## ACTON BOARD OF HEALTH

Re: Hazardous materials compliance  
Inspection.

# Hazardous Material/Waste Inspection Form

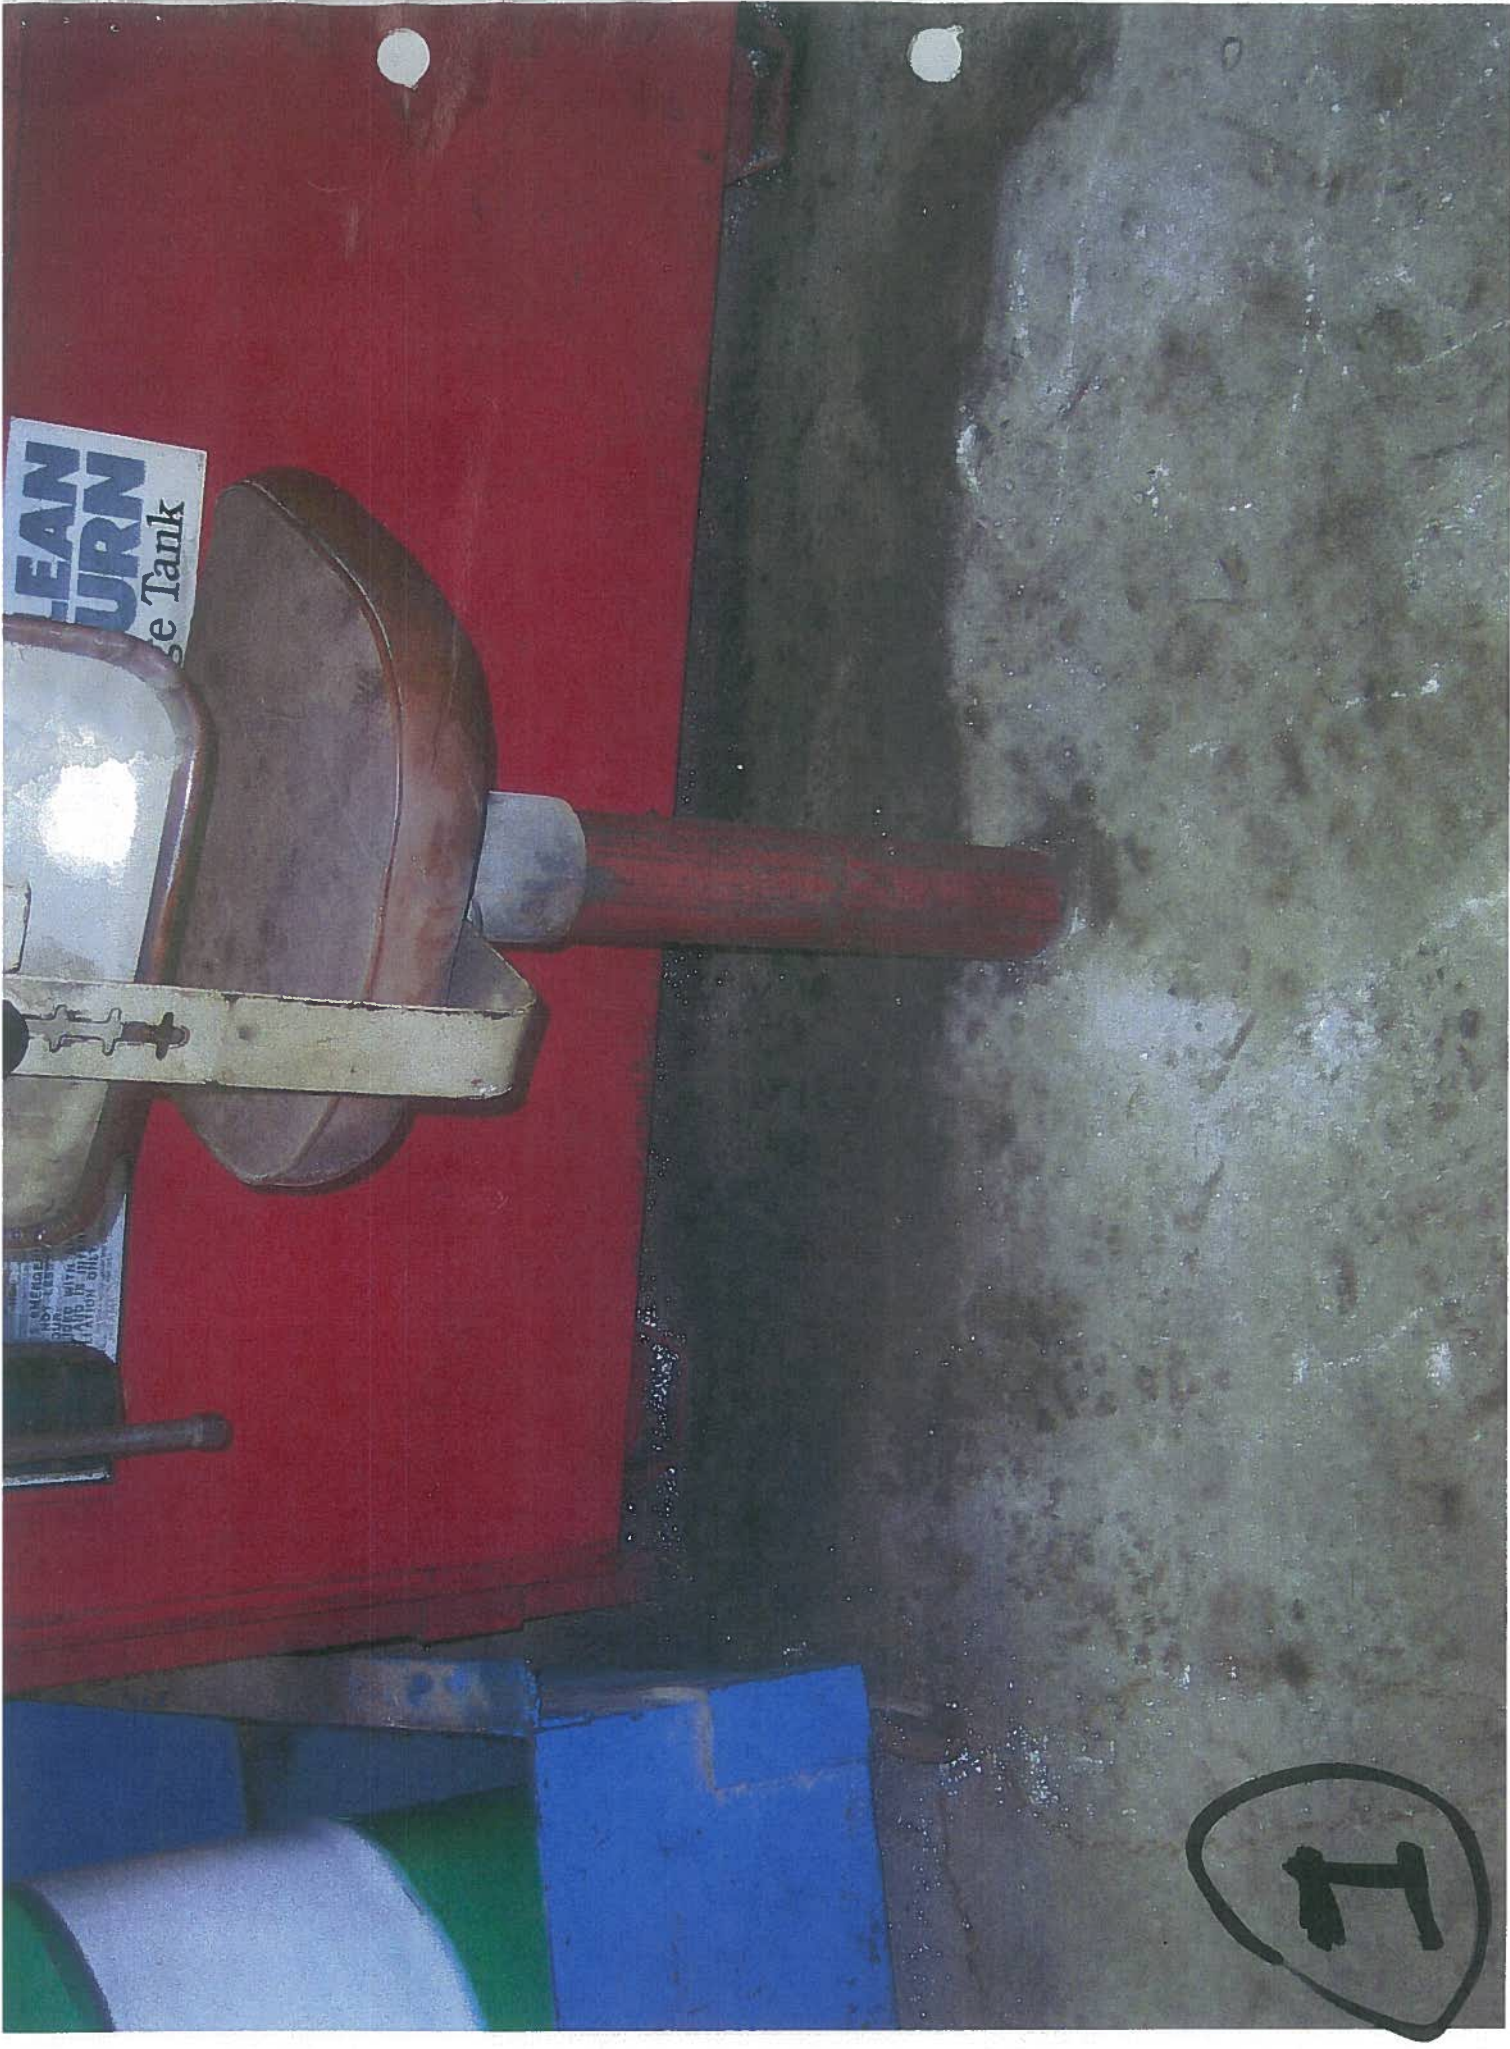
Outside Oil Tank lacks cover or 110% secondary containment. Tank is uneven/sinking and suggests unstable soil. Concrete pad is spotted with holes allowing for oil seepage into soil during spill. (see photo 3 & 4) Storage shed with oil tank sits on concrete floor. Floor is flooded with water. Brings into question the containment ability of the shed. Area must be cleaned (Photo 5 & 6) Spill stains are present near oil storage tank in front two bay work area. Some Speedy dry is present on floor, must be cleaned up. (Photo 1) Labels are not present on indoor storage area (see photo 2 ). Employees must be trained in proper clean up and emergency procedures. Site representative states that outside oil tank will be replaced with double wall tank or will build concrete pad with burms. Owner must provide time table for project and give details of actions to be taken. Dated and plan must be provided by March 1st.

Once repairs/update on outside tank is complete.  
Date of Tank Repair:
